**Zoning Ordinance Approval  
CITY OF AUSTIN  
RECOMMENDATION FOR COUNCIL ACTION**

**SUBJECT:** C14T-03-0001 - Pioneer Hill Traditional Neighborhood District - Approve second/third readings of an ordinance amending Chapter 25-2 of the Austin City Code by zoning property locally known as East Dessau Road, located across from the intersections of Dessau Road and Applegate Drive, Dessau Road and Meadowmead Drive, and Dessau Road and Childress Drive (Walnut Creek Watershed) from interim-rural residence (I-RR) district zoning to traditional neighborhood (TN) district zoning. First reading on May 6, 2004. Vote: 7-0. Conditions met as follows: No conditions were imposed. Applicant: Estate of Fred C. Morse, Sr., Deceased (Scott N. Morse, Frederic C. Morse, III), JP Morgan Chase Bank, N.A. (Scott DeNeen), Continental Homes of Texas, L.P., dba Milburn Homes, L.P./ D.R. Horton Homes, L.P. (Dale Thorton). Agent: Milburn Homes, L.P./ D.R. Horton Homes, L.P. (Dale Thorton). City Staff: Sherri Gager, 974-3057.

**ZONING CHANGE REVIEW SHEET****CASE:** C14T-03-0001**Z.A.P. DATE:** March 16, 2004  
April 6, 2004**ADDRESS:** East Dessau Road-Located across from the intersections of Dessau Road and A

⑤ Mixed Residential Street (One Way Westbound)

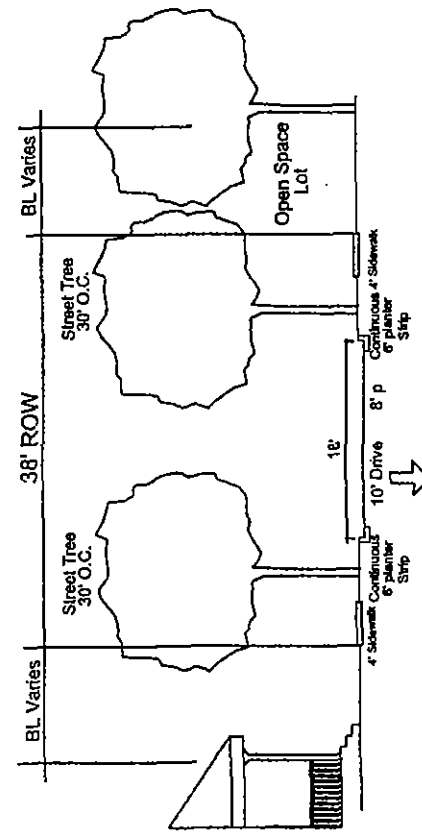
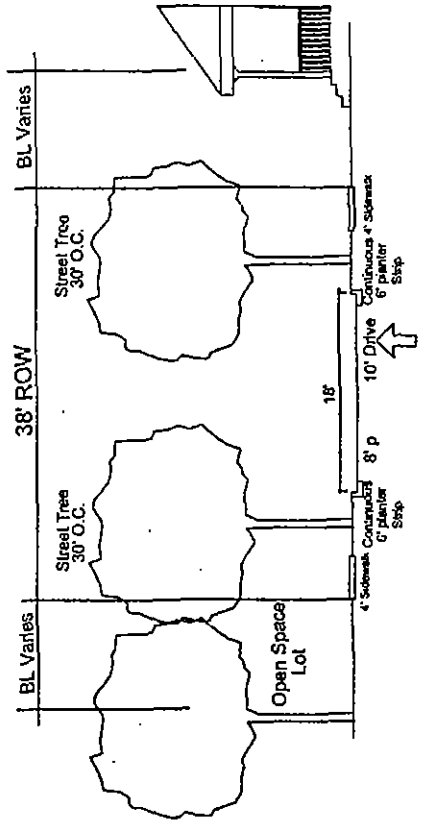
The applicant for the above referenced subdivision is requesting a variance to Title 25: Traditional Neighborhood District Criteria Manual Section 4.2 Street Classifications and Streetscapes Sections (TCM). The applicant requests the following change: A new street type, 4.2.3A Mixed Residential Street, which has a right-of-way width of thirty-eight (38) feet, parking permitted on one side and a paving section of eighteen (18) feet in one direction and four (4) foot sidewalks on either side.

- The cross section is similar to the existing Mixed Residential Boulevard. The change is requested so that a green space may be provide between the pavement sections and will serve as part of the hike and bike system that is present throughout the TND.
- The Transportation Planning and Sustainability Department (TPSD) has approved this proposed cross section.
- The use of the new cross section will be reviewed by TPSD during the subdivision process to ensure pedestrian safety, proper use of traffic controls, appropriate speed limit, and adequate design profiles.

**Recommendation:** Approve with conditions
